## General Information

*GI-1 Comparison between the topographical features in License Application (LA) Figures 1-3 and 1-4 gives the impression that the 640-acre plot would extend beyond the county sections represented in Figure 1-4. Consistent with NUREG-1520, Section 1.1.4.3(2), trace out the 640-acre property on LA Figure 1-4, similar to LA Figure 1-3, to clarify how county Sections 26, 27, 34 and 35 overlap with the 640-acre property.*

GI-2 *Consistent with the acceptance requirements presented in NUREG 1.2.4.3(4), provide a specific request for a license period such as 10 to 40 years.*

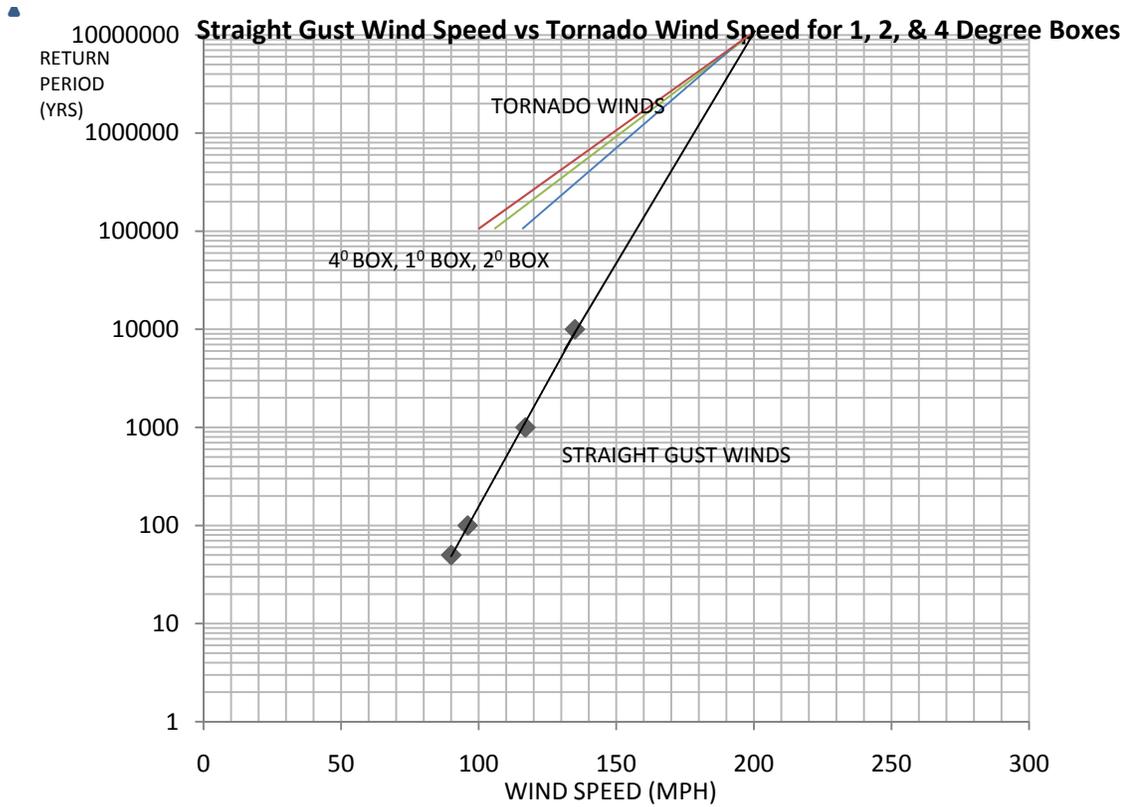
- C. *The basis quoted in ER Figure 3-27 for IIFP being outside the 100-year flood plain is based on data provided by the Economic Development Corporation (EDC) of Lea County, NM. In response to this RAI, provide a basis for the credibility of the information. Indicate if the EDC is qualified to develop these reports, or specify that the EDC compiled the information from nationally recognized sources. In addition, in the LA, ISA Summary, and ER, provide a basis for the statement that the IIFP is outside the 500-year flood plain.*

**License Documentation Impact:** The source reference for the floodplain information shown in Section 3.4.1.1, Figure 3-27 of Revision A of the IIFP Environmental Report will be changed from the EDC to include provider to EDC, FEMA and USGS.

Site grade is significantly above areas which have been mapped and are in the 100-year floodplain in and around Hobbs, New Mexico according to information provided in the FEMA Mapping Information Platform. These mapped areas and topographical data are displayed in Section 3.4.1.1, Figure 3-27, "Watercourses, Floodplains, and Playas Map" for location of FEMA Zone A (areas inundated during 100-year flood event). This map was provided to the Economic Development Council of Lea County by Gordon Environmental Inc. who references FEMA as the
